13 May 2024

Mareeba Shire Council
65 Rankin Street
PO Box 154
Mareeba QLD 4880

**Response to Pre-Request for Information
2-4 Quill Street, Mareeba (OPW/21/0006)**

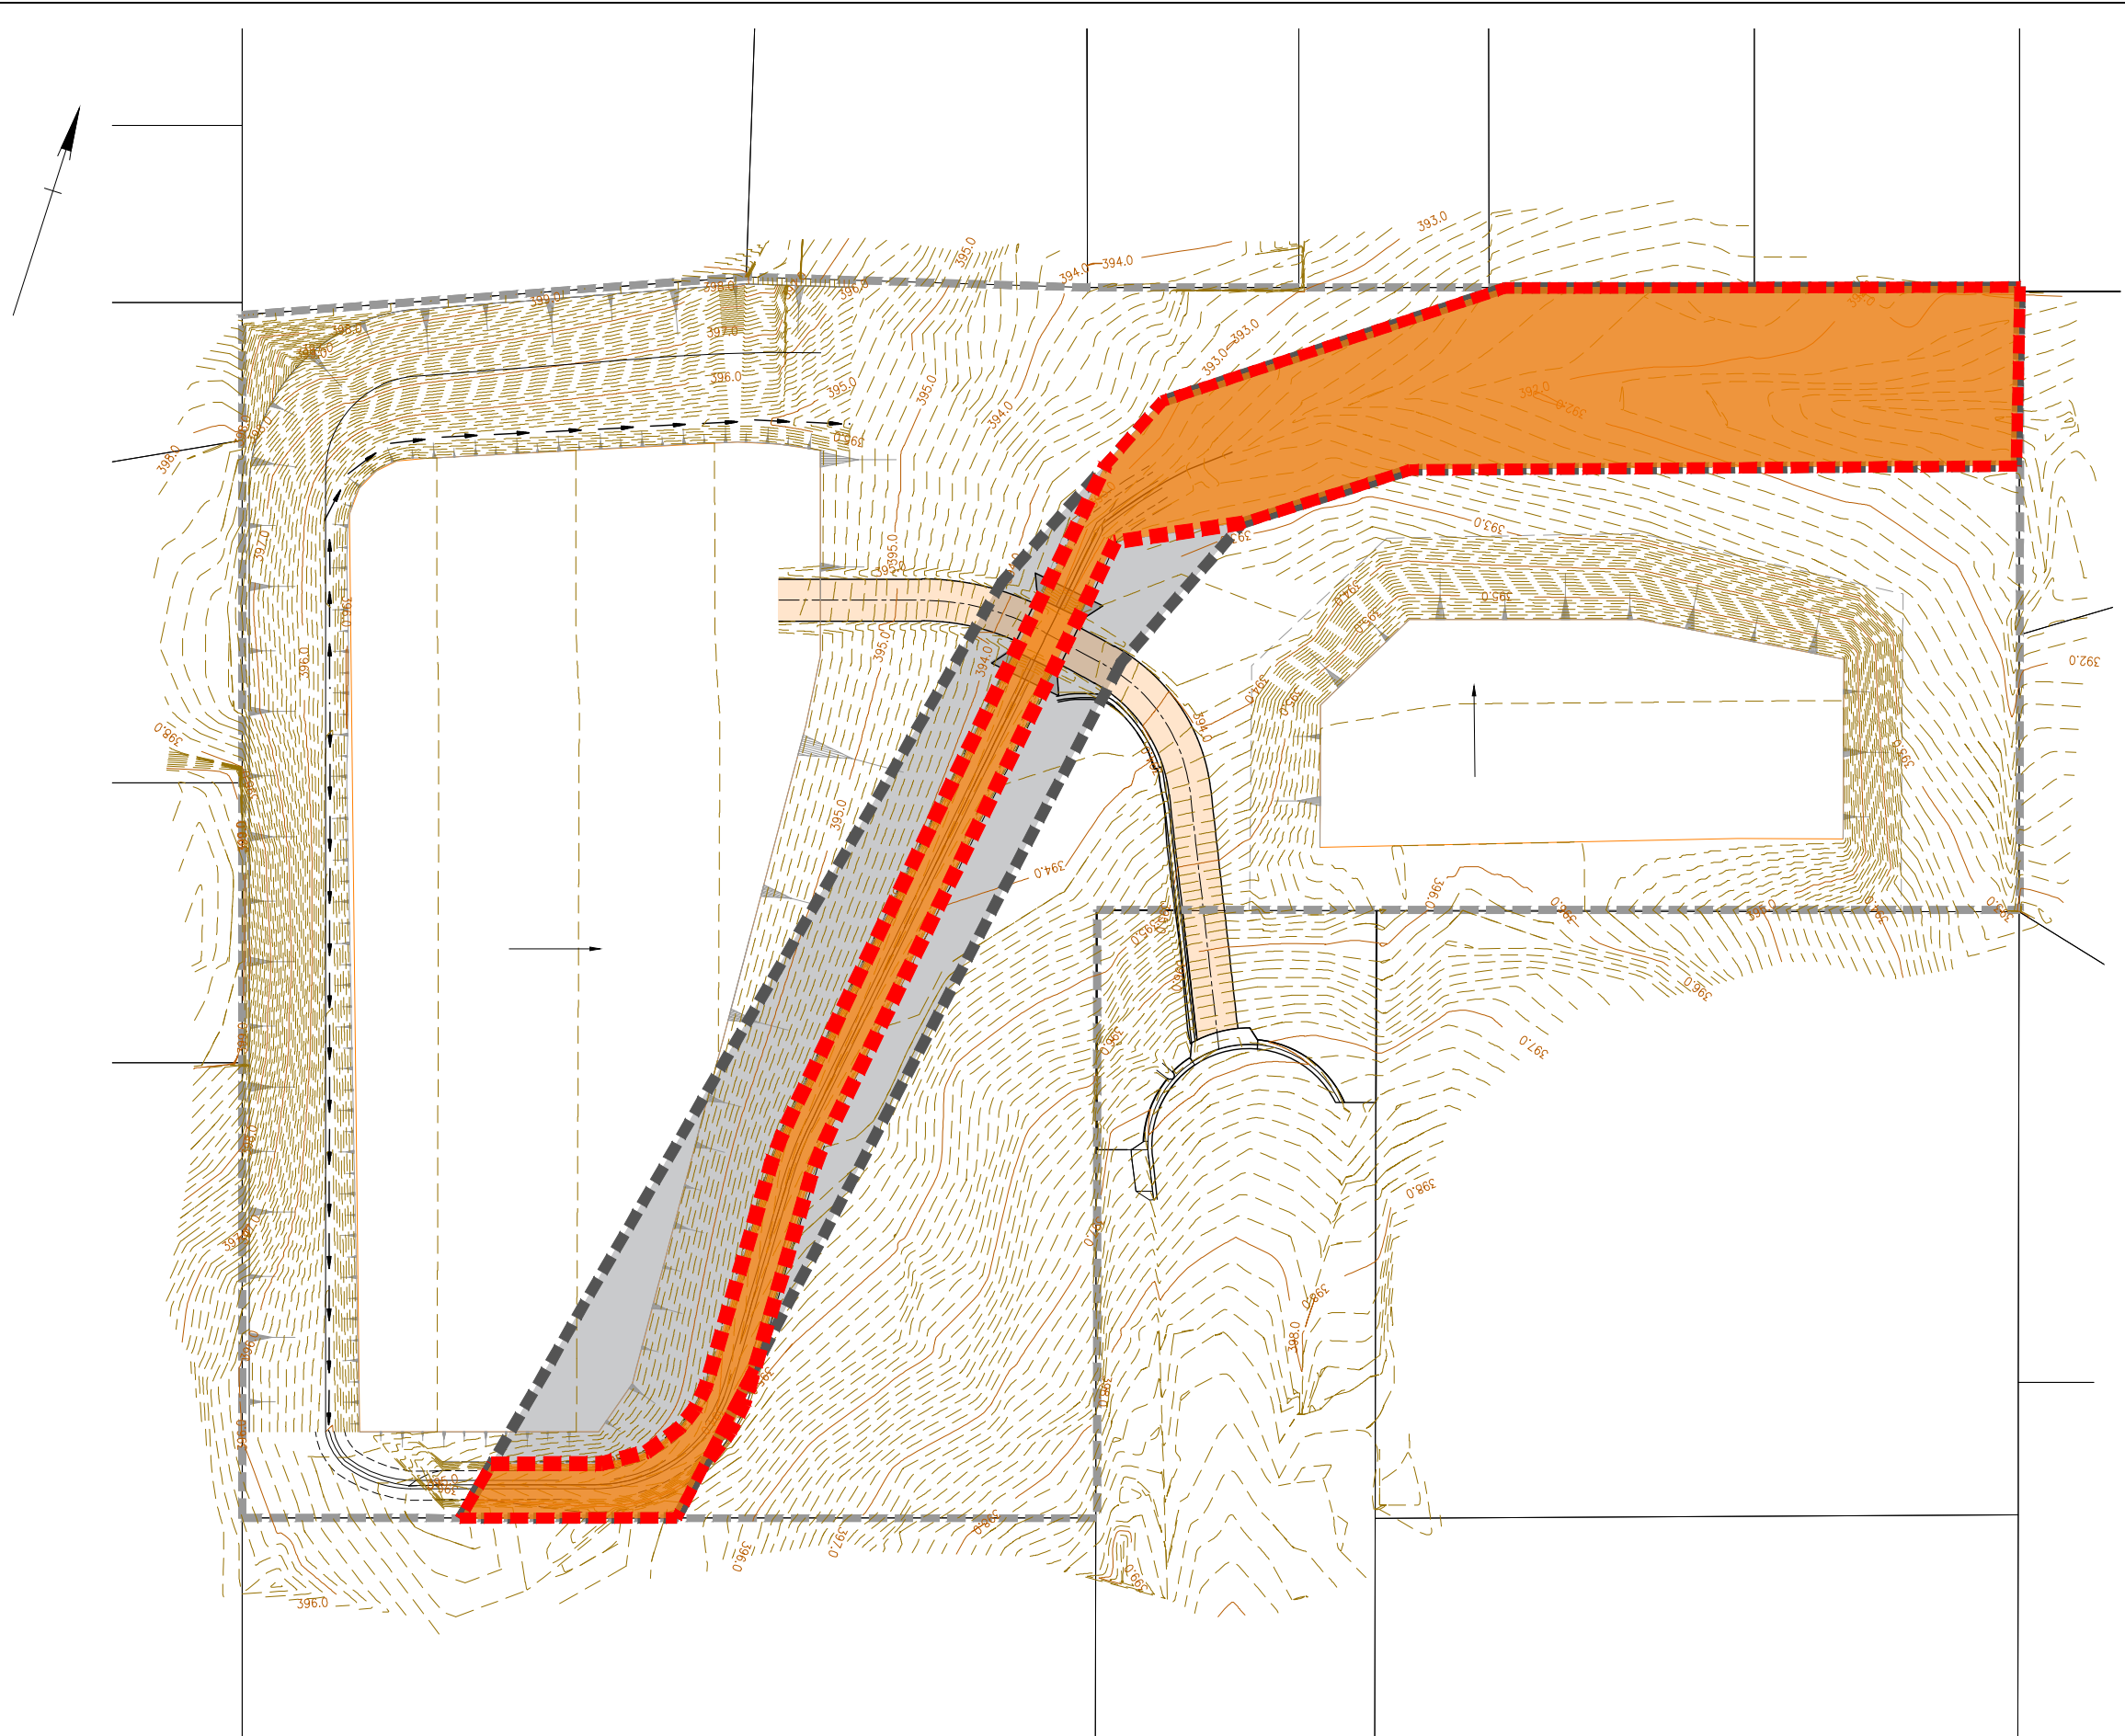
4. The drawings must be amended to show the location and extents of the existing drainage easement through the property.

No filling or retaining wall works for the building envelopes are to intrude into the drainage easement.

Advice Note: An approximate overlay of the easement from Queensland Globe data set appears to show the southern part of Building Pad 1 and a significant portion of the eastern batter to Building pad 1 encroaching into the easement.

5. The drawings must identify any proposed changes to the drainage easement to reflect the proposed additional drains nominated for construction under this application.

The southern corridor of the new drainage easement has been redirected and contained within the new drainage alignment. The previous drainage easement would have been created with the natural surface of the undeveloped land using the existing flow path and land profile. The engineered profile shows the Q100 will be contained within the 3.0m wide easement of the new alignment. See sketch drawing 160-001-SK09 rev 1.

The new alignment of the easement has been shown on sketch drawing 160-001-SK09 rev 1.

SEWER AND BATTER LOCATION
 SCALE 1:200 HORIZ.
 1:20 VERT.

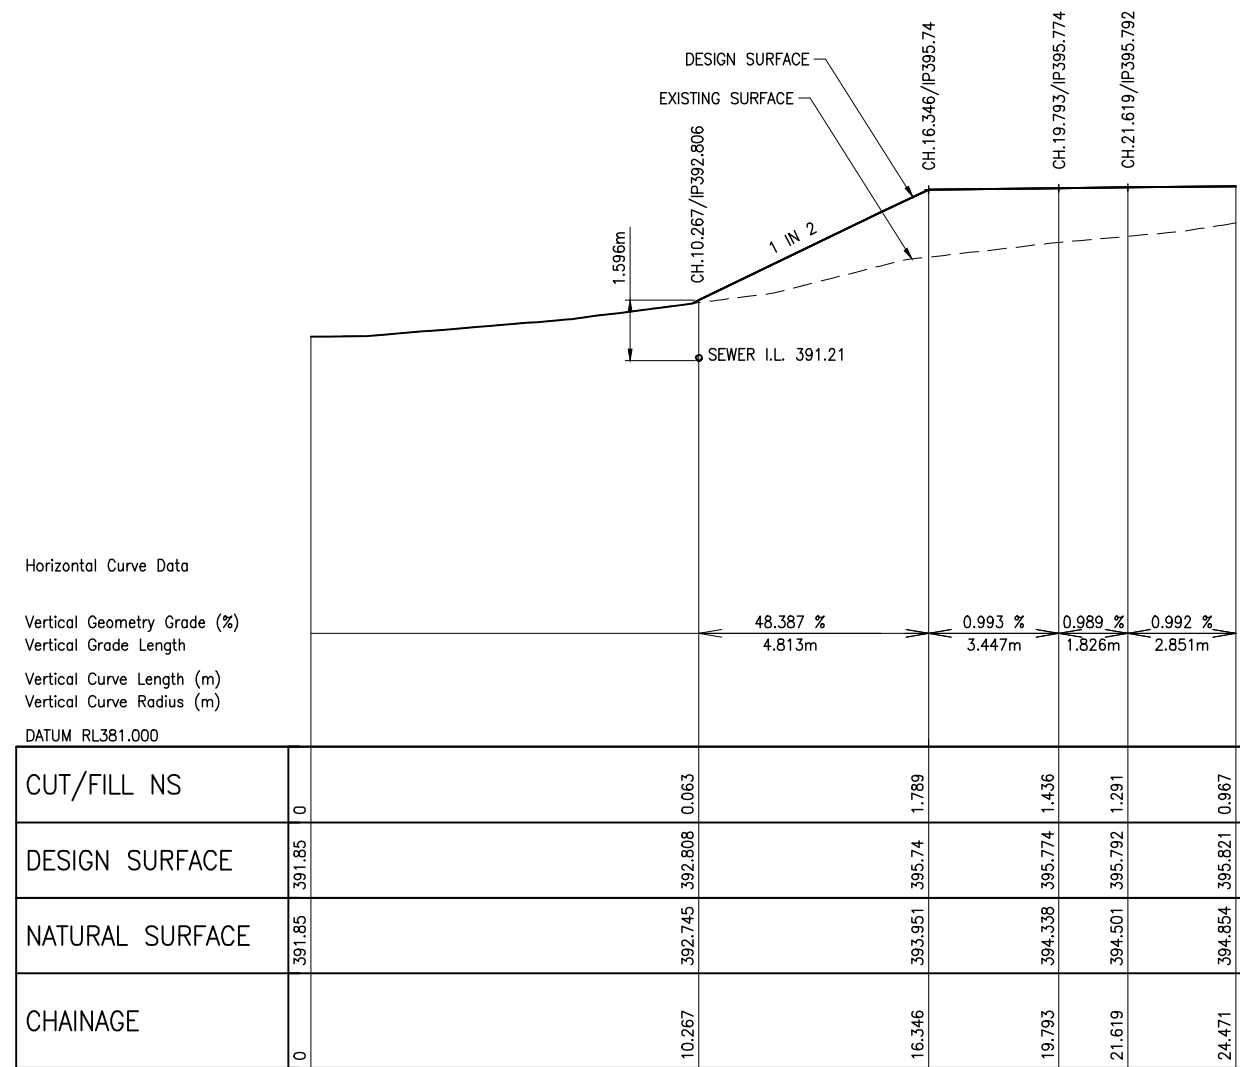
17. Provide a section through the Building Pad 2 fill platform and earth batter at the point closest to the sewer line. The section is to demonstrate the zone of influence for the sewer and confirm that the engineering solutions proposed ensure that the existing sewer main is not impacted by the new works. The details must also demonstrate that future maintenance of the sewer is not constrained by the new earthworks proposed.

That is; the sewer main must be able to be excavated in future without any special engineering solutions to prop or stabilise the proposed batter. If this cannot be achieved the design must be revised to achieve this sewer maintenance outcome.

The depth of excavation under the new battered surface to the sewer is 1.535m. No special engineering solutions should be required to excavate to this.
